# UNITED STATES PATENT AND TRADEMARK OFFICE

10/552,239

Claude Juneau

<b>Office Action Summary</b>	<b>Application No.</b> 10/552,239	<b>Applicant(s)</b> JUNEAU, CLAUDE	
	<b>Examiner</b> ERNESTO A. GRANO	<b>Art Unit</b> 4147

**FIG 10**

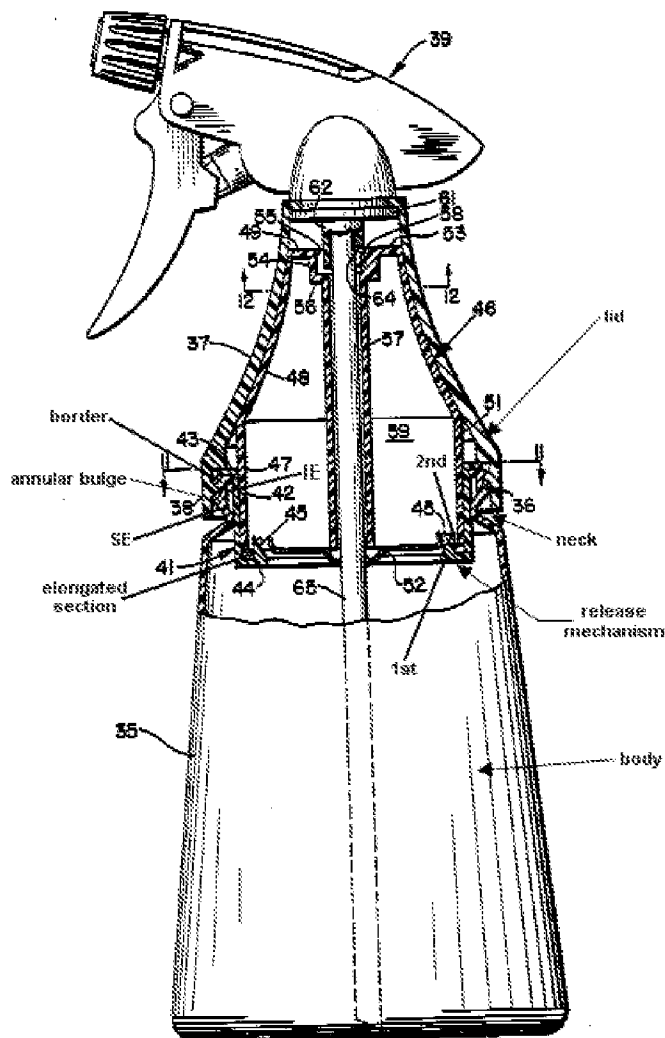
5. In re claim 1, with reference to figure 10, Klinganman ('246) discloses a device for a container provided with an opening and a flexible wall, the device comprising : at least one tank (46) insertable into the container (35) in an operating position; at least one release mechanism insertable into the container (35) in operating position, said release mechanism being capable of cooperating with the tank in order to connect the tank with the interior of the container (35) in response to a pressure exerted on said

release mechanism via the wall of the container(35); a support means (41) insertable into the container (35) to support in operating position the tank and the release mechanism in relation to the container (35), the support means (41) having a fastener (36) to fix the support means (41) on the container (35) close to the opening.

6. In re claim 2, with reference to figure 10, Klinganman ('246) discloses wherein the container opening is a neck, characterized in that the fastener (36) comprises an annular bulge capable of cooperating with an inferior edge (IE) of the neck and a collar (38) capable of cooperating with a superior edge (SE) of the neck, the bulge and the collar (38) allowing to fix the support means (41) on the container (35).

7. In re claim 4, with reference to figure 10, Klinganman ('246) discloses the release mechanism consists of an elongated section having a first end connected to a weakened section of the tank (52), whose rupture connects the tank (46) with the interior of the container (35), and a second end adjacent, in operating position, to the flexible wall of the container (35) to receive the pressure exerted via the wall of the container (35).

8. In re claim 10, with reference to figure 10, Klinganman ('246) discloses wherein the device consists of a material chosen in the group comprising metal, plastic, paperboard, glass and an alloy of metal. See column 4, paragraph 4 (last paragraph)

9. In re claim 21, with reference to figure 10, Klinganman ('246) discloses wherein the support means (41) is made of a flexible material. Column 2, lines 9 and 10

12. In re claim 6, with reference to figure 10, Klinganman ('246) as applied to claim 1 above, discloses the claimed invention except for at least one tank comprises between two and four tanks. It would have been obvious to one having ordinary skill in the art at the time the invention was made to replace the tank (46) of Klinganman ('246) with four smaller tanks to align with the four projections (45), since it has been held that mere duplication of the essential working parts of a device involves only routine skill in the art. *St. Regis Paper Co. v. Bemis Co.*, 193 USPQ 8.

13. In re claim 7, with reference to figure 10, Klinganman ('246) discloses the release mechanism consists of an elongated section having a first end connected to a weakened section of the tank (52), whose rupture connects the tank (46) with the interior of the container (35), and a second end adjacent, in operating position, to the flexible wall of the container (35) to receive the pressure exerted via the wall of the container (35).

14. In re claim 9, with reference to figure 10, Klinganman ('246) discloses wherein the release mechanisms are distributed, in operating position, regularly along the wall of the container (35).

15. In re claim 12, with reference to figure 10, Klinganman ('246) discloses the a container comprising a body and a lid, characterized in that the fastener (36) comprises a border capable of cooperating with a superior edge of the container, the border allowing to fix the support means (41) on the container (35).

16. However, Klinganman ('246) fails to disclose wherein the container is a can.

17. Since applicant has not disclosed that including a can as the container solves any stated problem or is for any particular purpose and it appears that container of Klinganman ('246) would perform equally well as a can, It would have been an obvious matter of design choice to include a can as the container Klinganman ('246).

18. In re claim 13, with reference to figure 10, Klinganman ('246) discloses wherein the support means (41) comprises at least one housing (42) to place at least one tank which, in operating position, is adjacent with the flexible wall.

19. In re claim 14, with reference to figure 10, Klinganman ('246) discloses wherein at least one tank comprises a perforable flexible wall. See column 4, paragraph 4 (last paragraph)

20. In re claims 15 and 20, with reference to figure 10, Klinganman ('246) discloses wherein the release mechanism consists of a tooth (45) having a first end (1<sup>st</sup>) fixed to the support means (41) and a second end (2<sup>nd</sup>) adjacent to the tank to perforate the tank and to connect it to the interior of the container (35) when said pressure is exerted.

21. However, Klinganman ('246) fails to disclose wherein the second end is a blunt end.

22. Since applicant has not disclosed that including a blunt end solves any stated problem or is for any particular purpose and it appears that second end (2<sup>nd</sup>) of Klinganman ('246) would perform equally well as a blunt end, It would have been an obvious matter of design choice to include a blunt end to the support means (41) of Klinganman ('246).

23. In re claim 19, with reference to figure 10, Klinganman ('246) as applied to claim 1 above, discloses the claimed invention except for at least one tank comprises

six tanks. It would have been obvious to one having ordinary skill in the art at the time the invention was made to replace the tank (46) of Klinganman ('246) with six smaller tanks to align with six projections, since it has been held that mere duplication of the essential working parts of a device involves only routine skill in the art. *St. Regis Paper Co. v. Bemis Co.*, 193 USPQ 8.
